SUBJECT: Beaver Valley Power Station - Unit No. 2  
Docket No. 50-412  
Electrical Separation Criteria

The attached information is provided to close outstanding issues related to Regulatory Guide 1.75 electrical separation at BVPS-2. This attachment consists of the following information:

2. FSAR changes based on this test program including:

- ° FSAR 1.8 (Regulatory Guide Position)
- ° FSAR 8.3.1.4 (Independence of Redundant Systems)
- ° FSAR Figures 8.3-16 through 8.3-73

FIGURE 8.3-59

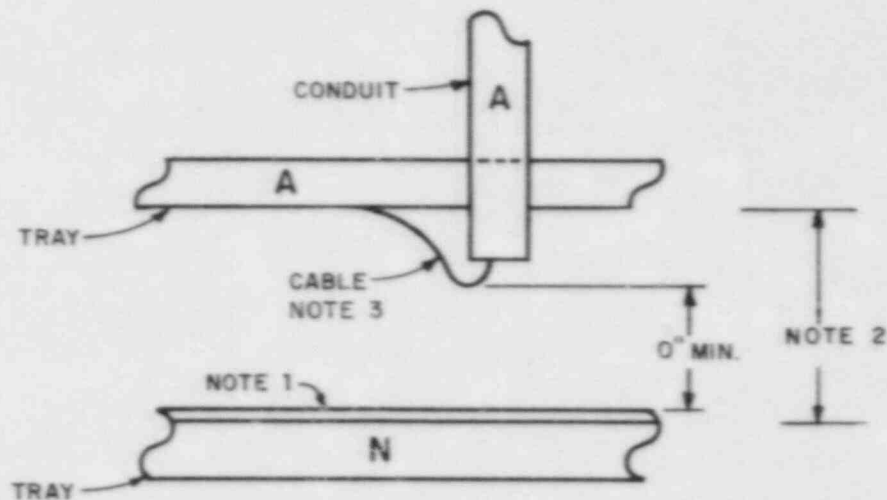
In the GPA, where a 1 in. minimum vertical free air space between Class 1E and non-Class 1E trays is maintained and a tray cover is provided in accordance with Figure 8.3-17, Detail A, where a Class 1E cable enters the Class 1E tray and is enclosed in a protective wrap, separation between the Class 1E cable and the non-Class 1E tray may be reduced to 0 in. as shown on Figure 8.3-59.

FIGURE 8.3-60

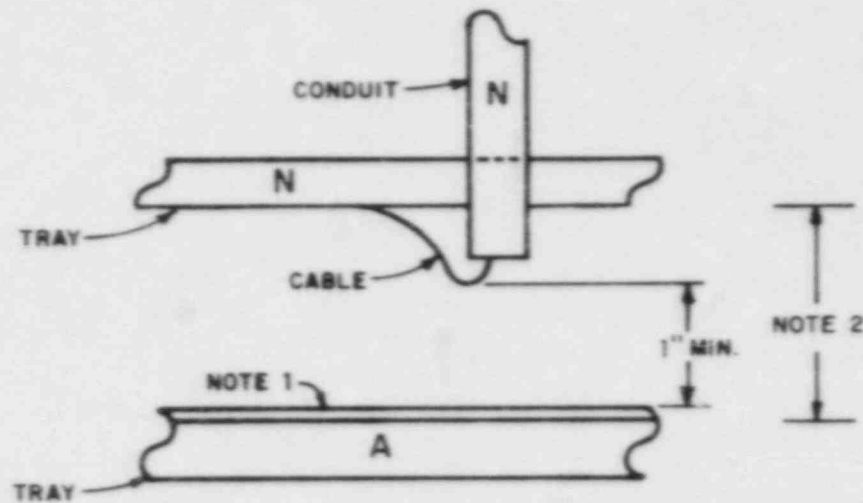
In the GPA, where a 1 in. minimum vertical free air space between non-Class 1E and Class 1E trays is maintained and a tray cover is provided in accordance with Figure 8.3-17, Detail C, where a non-Class 1E cable enters the non-Class 1E tray, separation between the non-Class 1E cable and the Class 1E tray may be reduced to 1 in. as shown on Figure 8.3-60.

FIGURE 8.3-61

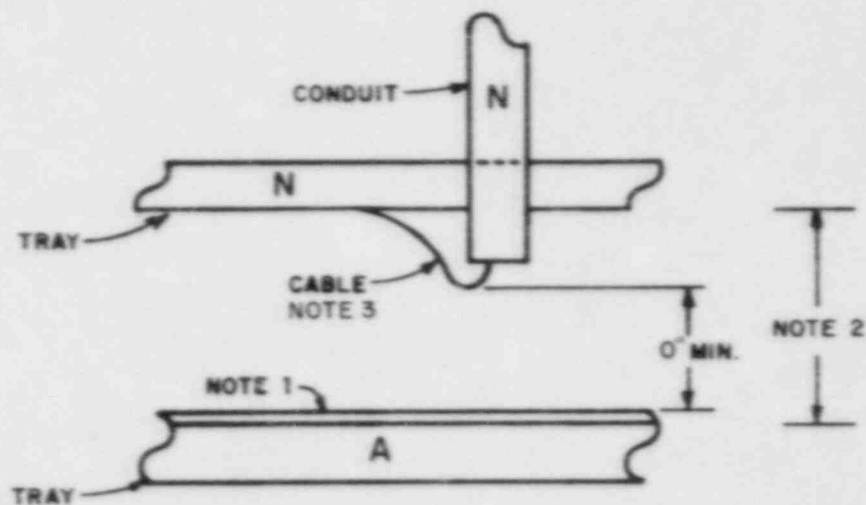
In the GPA, where a 1 in. minimum vertical free air space between non-Class 1E and Class 1E trays is maintained and a tray cover is provided in accordance with Figure 8.3-17, Detail C, where a non-Class 1E cable enters the non-Class 1E tray and is enclosed in a protective wrap, separation between the non-Class 1E cable the Class 1E tray may be reduced to 0 in. as shown on Figure 8.3-61.

FIGURE 8.3-62

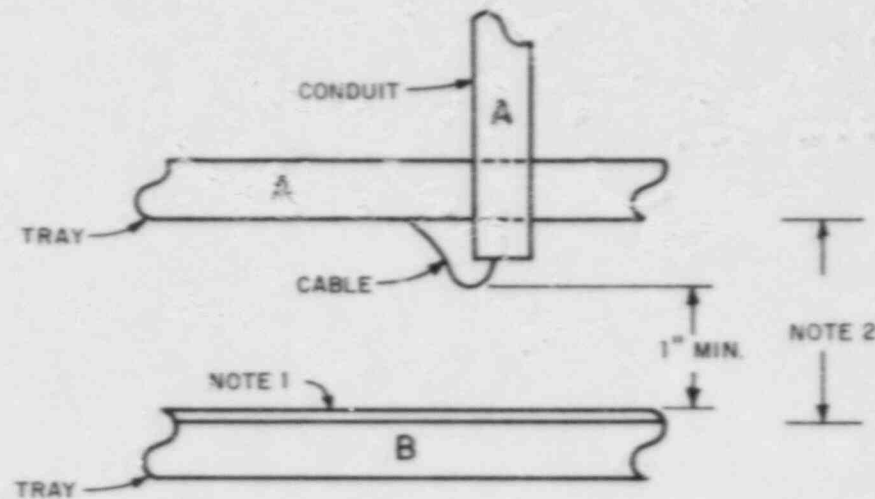
In the CSA, where a 1 in. minimum vertical free air space is maintained between redundant Class 1E trays and a tray cover is provided in accordance with Figure 8.3-24, Detail A, where a cable enters the upper tray, separation between the Class 1E cable and

the redundant Class 1E tray may be reduced to 1 in. as shown on Figure 8.3-62.

FIGURE 8.3-63  
CABLE SPREADING AREAS (CSA)  
ACCEPTABLE SEPARATION  
ARRANGEMENT  
BEAVER VALLEY POWER STATION-UNIT 2  
FINAL SAFETY ANALYSIS REPORT

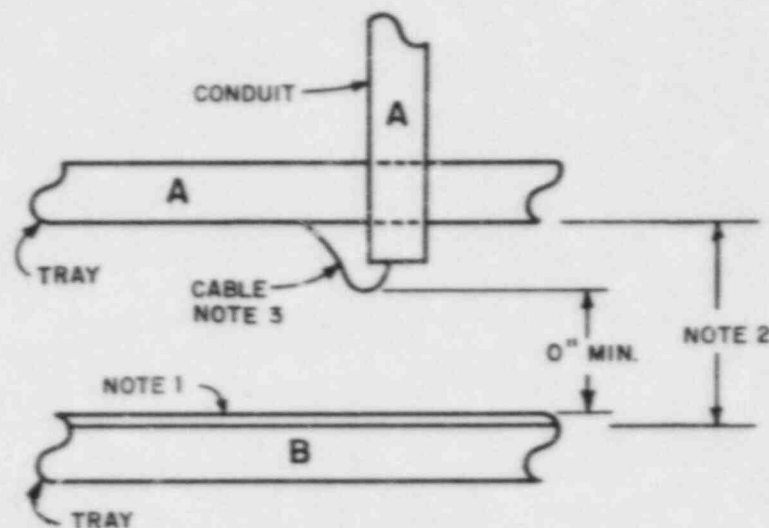
In the CSA, where a 1 in. minimum vertical free air space is maintained between redundant Class 1E trays and a tray cover is provided in accordance with Figure 8.3-24, Detail A, where a cable enters the upper tray and is enclosed in a protective wrap, separation between the Class 1E cable and the redundant Class 1E cable tray may be reduced to 0 in. as shown on Figure 8.3-63.

FIGURE 8.3-64

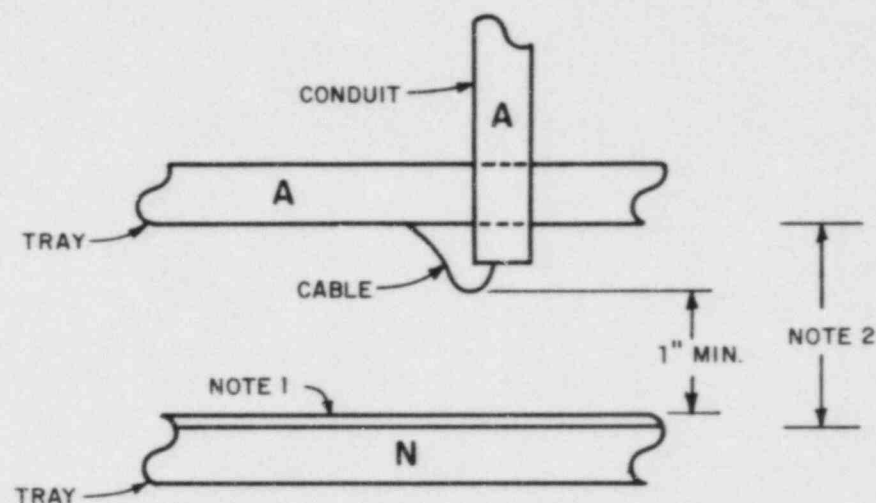
In the CSA, where a 1 in. minimum vertical free air space between Class 1E and non-Class 1E trays is maintained and a tray cover is provided in accordance with Figure 8.3-25, Detail A, where a Class 1E cable enters the Class 1E tray, separation between the Class 1E cable and the non-Class 1E tray may be reduced to 1 in. as shown on Figure 8.3-64.

FIGURE 8.3-65

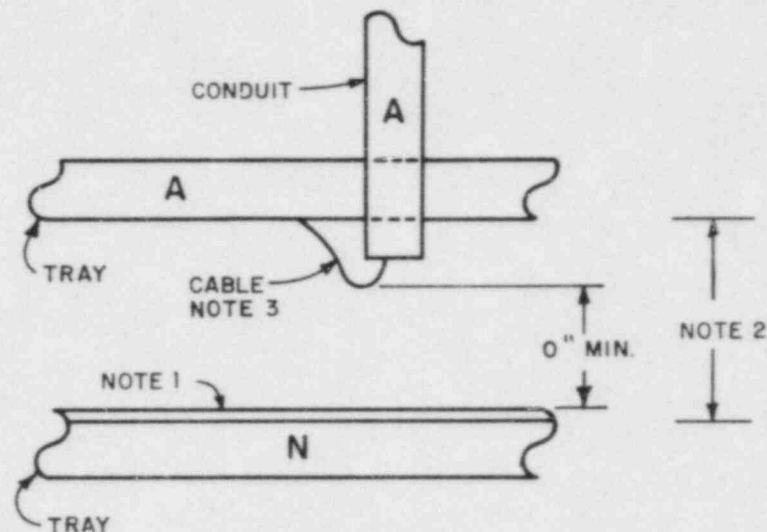
In the CSA, where a 1 in. minimum vertical free air space between Class 1E and non-Class 1E trays is maintained and a tray cover is provided in accordance with Figure 8.3-25, Detail A, where a Class 1E cable enters the Class 1E tray and is enclosed in a protective wrap, separation between the Class 1E cable and the non-Class 1E tray may be reduced to 0 in. as shown on Figure 8.3-65.

FIGURE 8.3-66

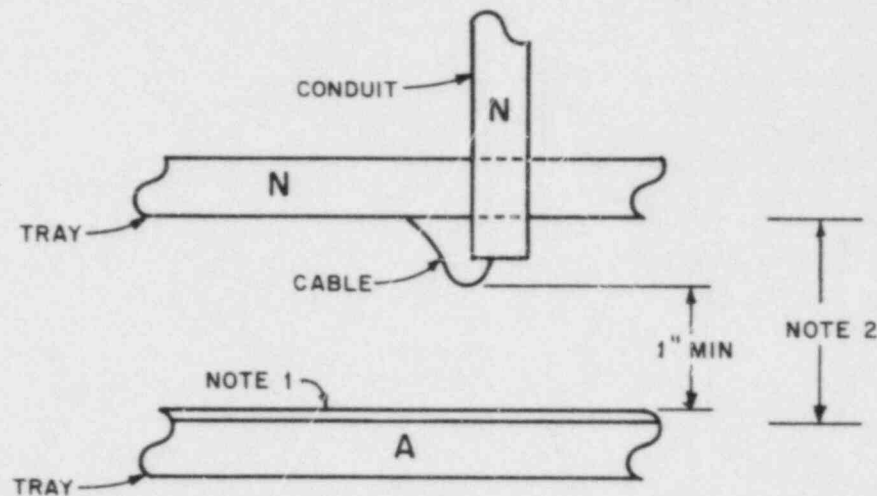
In the CSA, where a 1 in. minimum vertical free air space between non-Class 1E and Class 1E trays is maintained and a tray cover is provided in accordance with Figure 8.3-25, Detail C, where a

non-Class 1E cable enters the non-Class 1E tray, separation between the non-Class 1E cable and the Class 1E tray may be reduced to 1 in. as shown on Figure 8.3-66.

FIGURE 8.3-67

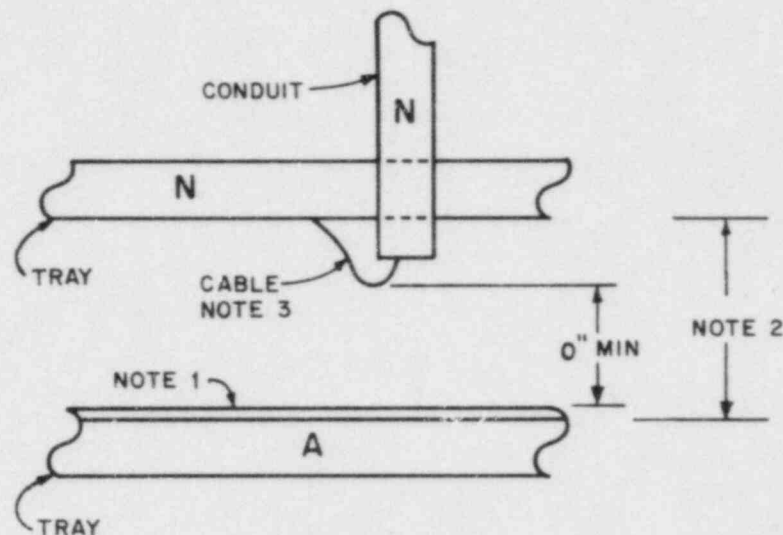
In the CSA, where a 1 in. minimum vertical free air space between non-Class 1E and Class 1E tray is maintained and a tray cover is provided in accordance with Figure 8.3-25, Detail C, where a non-Class 1E cable enters the non-Class 1E tray and is enclosed in a protective wrap, separation between the non-Class 1E cable and the Class 1E tray may be reduced to 0 in. as shown on Figure 8.3-67.

FIGURE 8.3-73  
 RAISED HAT TRAY COVER  
 BEAVER VALLEY POWER STATION-UNIT 2  
 FINAL SAFETY ANALYSIS REPORT

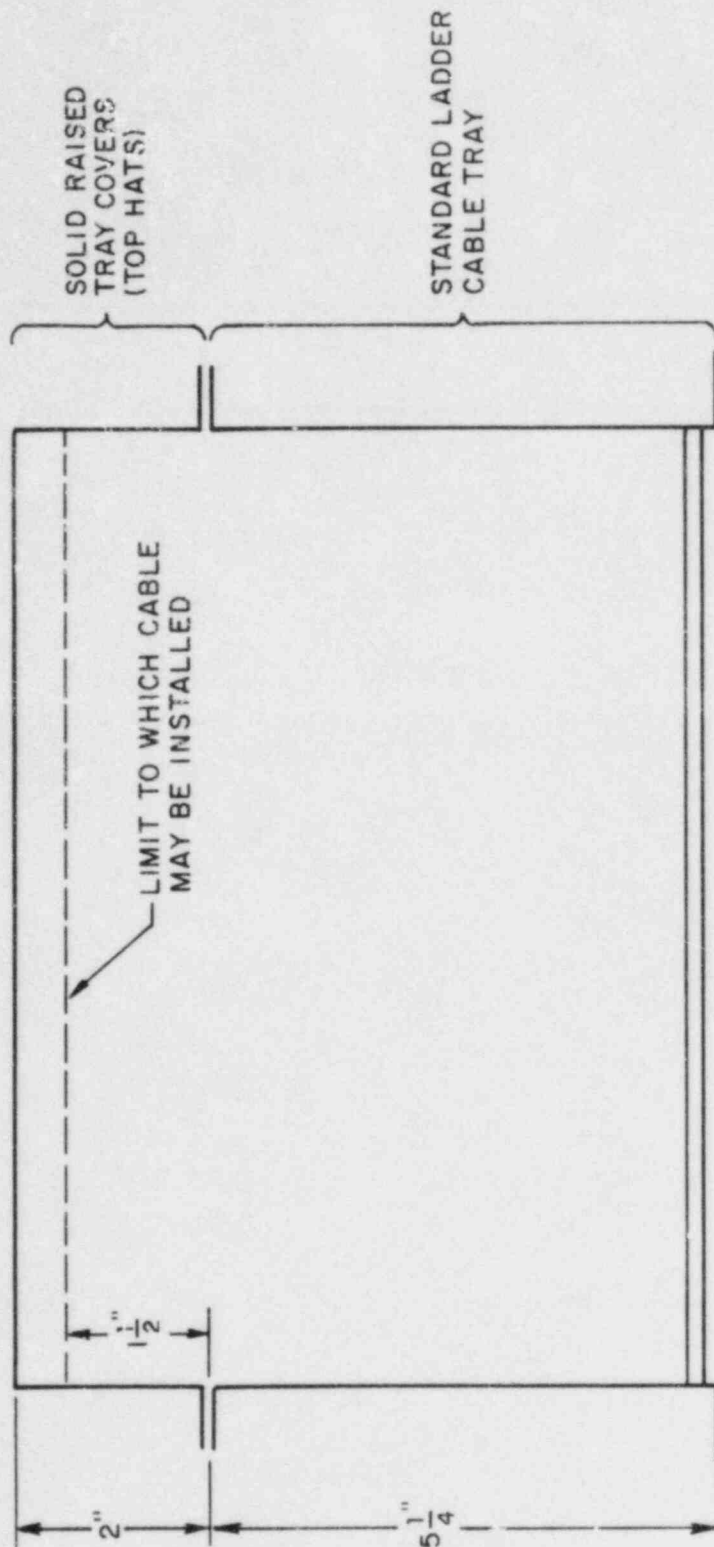
Cable trays for control and instrumentation cables may be filled above the side rails where the overfill has been limited to a maximum of 1 1/2 in. above the top of the side rail and where solid hat covers with a 2 in. raised flat center section are used to enclose the top of the cable tray as shown on Figure 8.3-73.
